**SERVICE BULLETIN****SB20-06**

**TECHNICAL PORTIONS  
FAA APPROVED****SUBJECT:** Hydraulic Lifter Assemblies**PURPOSE:** Inspect and replace affected hydraulic lifter assemblies (Part No. 657912) or lifter sockets (Part No. 657917) shipped by Continental between *17 January 2019* and *22 October 2020*.**COMPLIANCE:** Inspection upon notification of this service bulletin and replacement by next 100-Hour, Annual, or Progressive inspection, or maintenance event.**MODELS****AFFECTED:** Continental Aerospace Technologies new or rebuilt C90; C125; C145; 0200A, B, C, D; 0300A, B, C, D; G0300A, B, C, D, and RR C90; RR 0200A, B, C; RR 0300A, B, C, D aviation gasoline (AvGas) engines assembled, overhauled or repaired with affected 657912 lifter assemblies or 657917 lifter sockets.**I. GENERAL INFORMATION**

**Figure 1. Lot Code Marking Location**

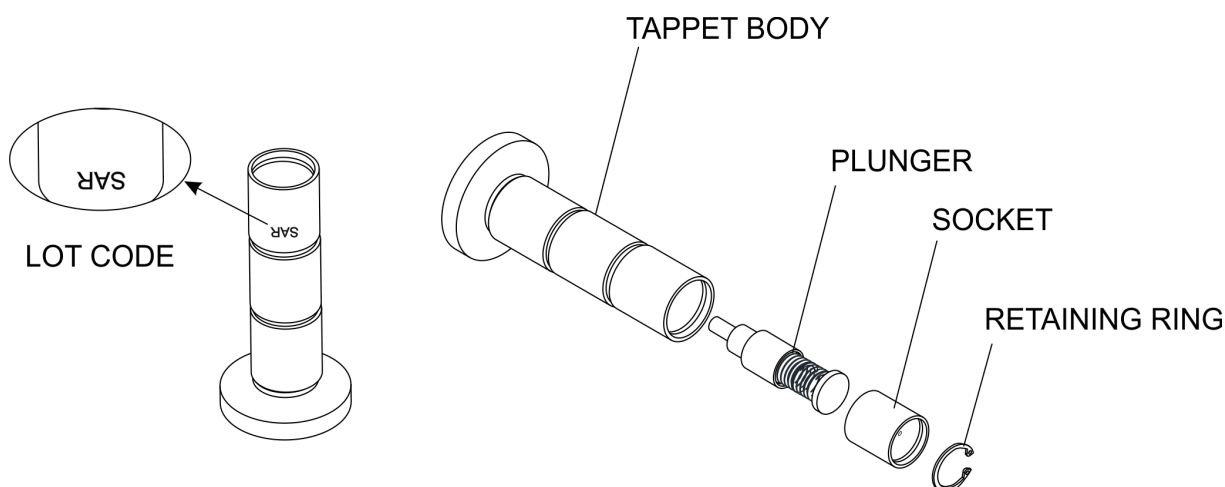
The suspect nonconforming hydraulic lifter sockets have no identifying marks. A lot code is etched near the top of the lifter bodies (see Figure 1). The lot code is visible in the crankcase with the pushrod housings and pushrod adapters removed from the crankcase and the camshaft rotated to the top of the lobe. Affected lifter assemblies lots, listed in Table 3 contain the suspect sockets. Lifter assemblies (Part No. 657912) with these lot codes must be removed from inventory and service unless the socket is replaced.

**Figure 3. 4.062 Inch Cylinder Assembly**

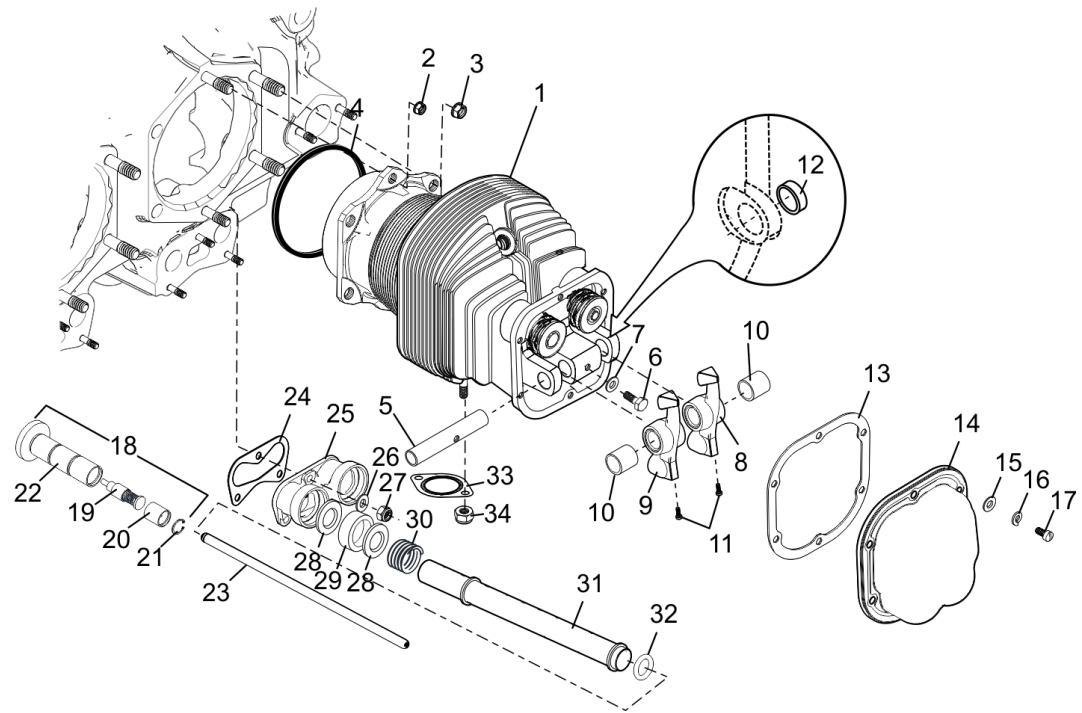
10. Remove the retaining ring from the hydraulic lifter assembly, discard the retaining ring.
11. With the retaining ring removed, the socket should rise above the tappet body. Remove the socket from the tappet body.

12. Install the new hydraulic lifter socket in the tappet body and compress the assembly until the snap-ring groove is visible. Install the new retaining ring in the groove and release tension on the socket. Verify the retaining ring is securely seated in the groove. Repeat for all hydraulic lifter locations.
